**Government of India**  
**Ministry of Railways**  
**Research, Designs & Standards Organisation**  
**Manak Nagar, Lucknow - 226 011**

**MODIFICATION SHEET No. RDSO/WAM4/108**

**Replacement of indigenous double coil springs by indigenous  
single coil springs of pantograph type AM12 of  
M/s Stone Platt Electricals (India)Ltd.**

SK.EL-3110

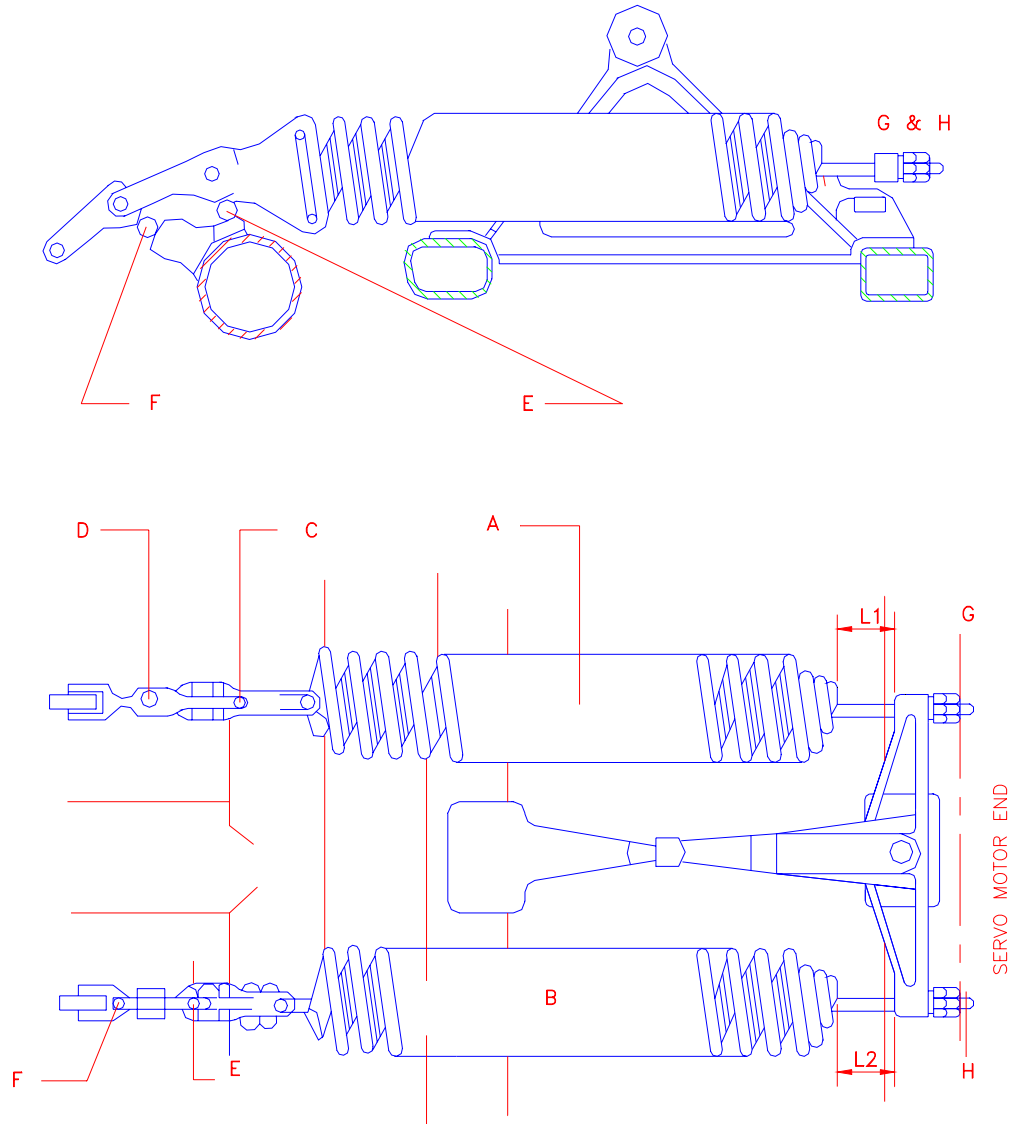
- 2.1** Replace the old indigenous main springs A and B along with the end fittings by new ones obtained from M/s SPEI along with modified and fittings. The old Indigenous springs can be easily identified as each main springs consists of a nest of two springs, on inside the other, while the new design has single springs
- 2.2** Balance the pantograph with the help of balancing screw C,D,E and F and main adjusting screws G and H in accordance with Special maintenance Instruction No. RDSO/ELRS/SMI/64 dated 8.2.80.

- 2.3 Measure and record gaps L1 and L2 as indicated in SK. EL. 3110 enclosed. Monitor the performance of the springs by measurements and Keeping record of gaps L1 and L2 during IC inspections and AOH. Advise results to RDSO after one year's service.
